Access Compliance Report Public Rights-of-Way (Curb Ramps)

Main Street: HOLT_AVE Cross Street: BENETA_WAY Location: SW

ADA ID: RPRK220121121021 Ramp Type: Type 4 - Parallel Initial Pass/Fail: Fail Overall Compliance: No Severity Score: 16

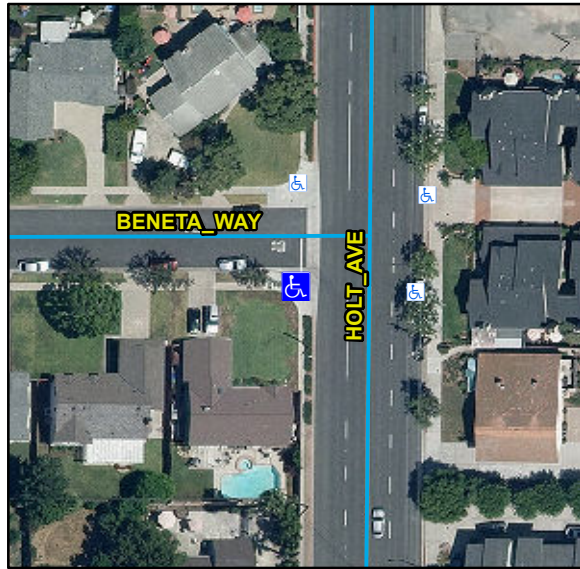
Compliance	Description	Data	Compliance	Description	Data
N/A	Ramp Length LT (in)	92	N/A	Ramp Length RT (in)	123
Yes	Ramp Width LT (in)	96	Yes	Ramp Width RT (in)	96
Yes	Ramp Run Slope LT (%)	3.2	No	Ramp Run Slope RT (%)	8.5
No	Ramp Cross Slope LT (%)	2.8	Yes	Ramp Cross Slope RT (%)	0.8
N/A	Landing Present	N/A	N/A	DWS Provided	N/A
N/A	Landing Length (in)	N/A	N/A	DWS Contrast	N/A
N/A	Landing Width (in)	N/A	N/A	DWS Length (in)	N/A
N/A	Landing Run Slope (%)	N/A	N/A	DWS Full Width	N/A
N/A	Landing Cross Slope (%)	N/A		DWS Offset Type	N/A
N/A	Landing Movement Obstructed?	N/A	N/A	DWS Offset Left (in)	N/A
	Landing Movement Type	N/A	N/A	DWS Offset Right (in)	N/A
N/A	Landing Shared	N/A			
N/A	Clear Space	Yes			
N/A	Clear Space To Crosswalk (in)	N/A			
N/A	Marked Crosswalk 1	No	N/A	Marked Crosswalk 2	No
	Crossing 1 Direction	E		Crossing 2 Direction	N
	Marked Crosswalk 1 Width (in)	N/A		Marked Crosswalk 2 Width (in)	N/A

Remove & Replace Curb Ramp With Two New Directional Ramps or Equivalent.

R304.5.3, R304.3.2, STD 1115
